**STAFF REPORT
ITEM NO. Two.**

APPLICANT: *Tommy Lasiter and Ryan Lasiter*

ADDRESS: *1300 S Scott Street*

COA REQUEST: *Infill Apartments*

West Elevations

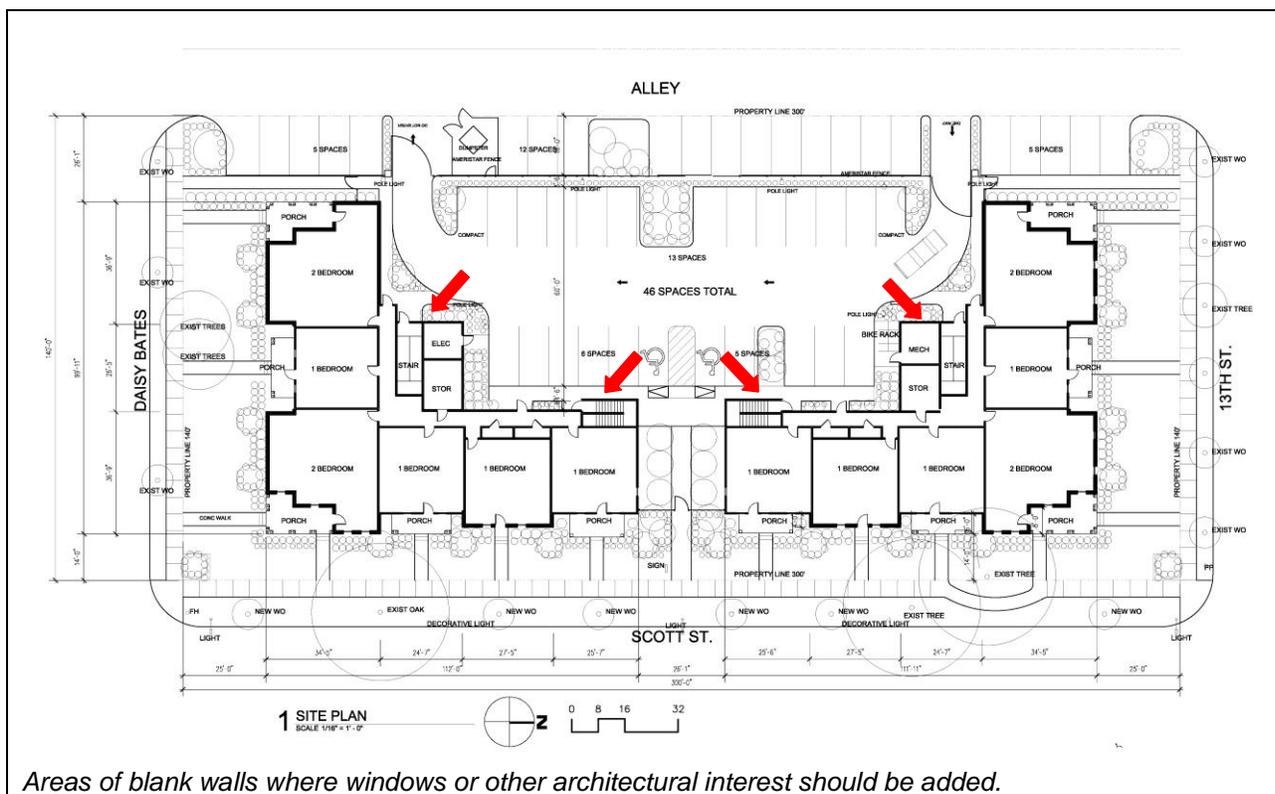
The dimension of the width of the HardiePlank was not specified nor was the texture. The trim boards around doors and windows, particularly abutting the HardiePlank was not specified either.

The applicant should consider adding windows or other architectural elements to break up the west walls in areas shown by red arrows below. Blank walls are not typical in a historic district.

Areas of blank walls where windows or other architectural interest should be added.

Site Design

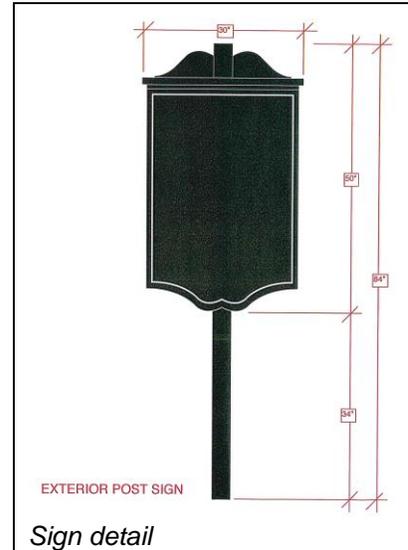
Signage: The sign specified will be a pole mounted sign 84" tall and 30" wide with the sign face to be approximately 7.25 square feet. The sign will be a powder coated metal sign located midblock off of Scott Street near the opening between the two apartment buildings. No light source was described.

1. Obtaining a building permit.
2. Light source for signage will be ground mounted and low wattage.
3. All satellite dishes will be installed on roof behind fencing.
